► AIRCRAFT

SUBJECT: IGNITION SWITCHES, ROTARY ACTION, KEY OR LEVER ACTUATED, TWIST-TO-START, PUSH-TO-START, TWIST-TO-START/PUSH-TO-PRIME TYPES.

REASON FOR BULLETIN:

Figure 1. Identification of Switch Parts.

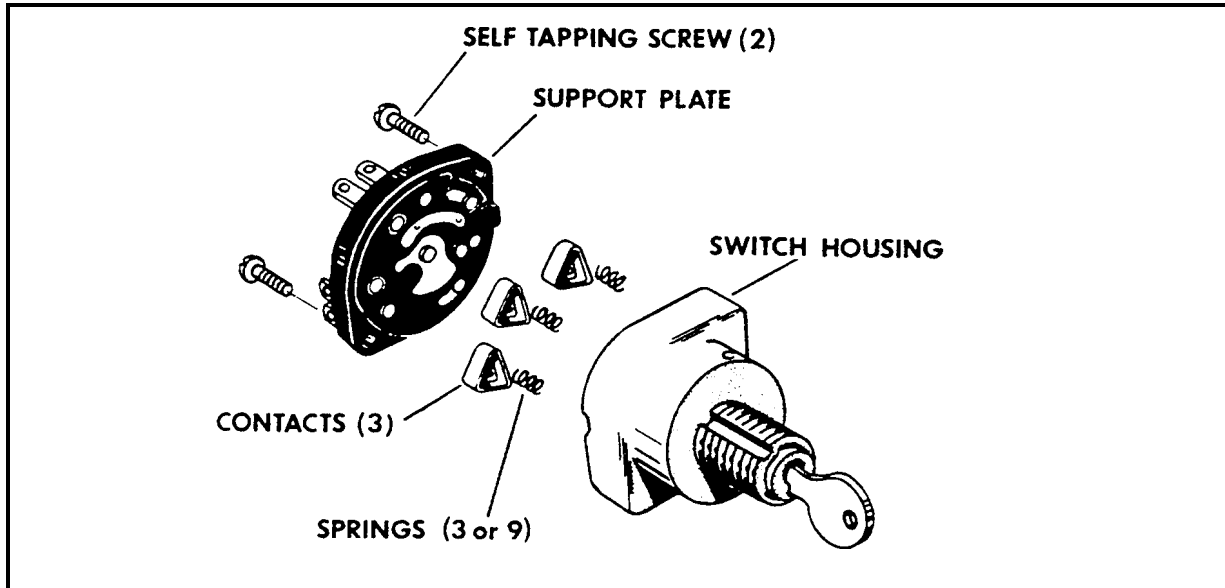
B. To install a new Support Plate and Contacts, proceed as follows using Figure 1 as a guide for parts identification.

c. Directly beneath the support plate are three contacts, spring loaded against the support plate. Carefully separate the support plate from the main switch assembly and remove the three contacts and springs (3 or 9).

- a. Reinstall contact loading springs (3 or 9) in rotor. Position new contacts over springs so contacts will move into triangular recesses when pressure is applied.
- b. Locate boss on new support plate over locating slot in switch housing
